IMPORTANT SAFETY RECALL NOTICE

NHTSA Campaign Number: **26V-385** Internal Recall Number: **207**

Winnebago Motorhomes has decided that certain 2026 – 2027 Winnebago Revel and Revel Sport fail to conform to Federal Motor Vehicle Safety Standard No. 110. “Tire Selection and Rims”. These vehicles were manufactured February 19, 2025, through May 23, 2026. These dates are a broad overview and non-sequential.

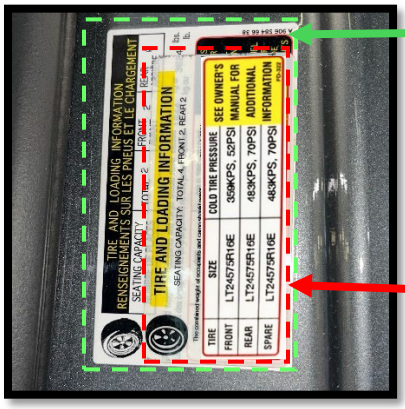
Defect: Certain Winnebago vehicles fail to comply with FMVSS 110 due to an incorrect tire size listed. The tire is listed as R16 when actual tire size is R17.

2. Remove and discard existing Tire and Loading Information Label, this will reveal the OEM chassis manufacturer's Tire Inflation Pressure Label.

KEEP OEM Chassis Manufacturer's Tire Inflation Pressure Label .

REMOVE and discard existing Tire and Loading Information Label

Winnebago Motorhomes has provided you with the correct Tire and Loading Information Label with this letter to install or you may also have this label installed by an authorized dealer. If you choose to have a dealer install, please bring the label provided with this letter to your appointment.

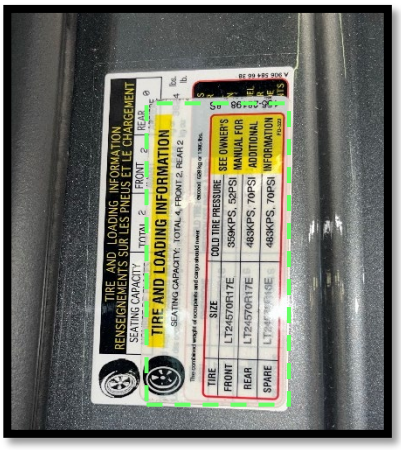
3. Clean the face of the OEM Label with Isopropyl alcohol and ensure it is dry. Then cover the OEM Tire Inflation Pressure Label with the new Tire and Loading Information Label provided in this letter.
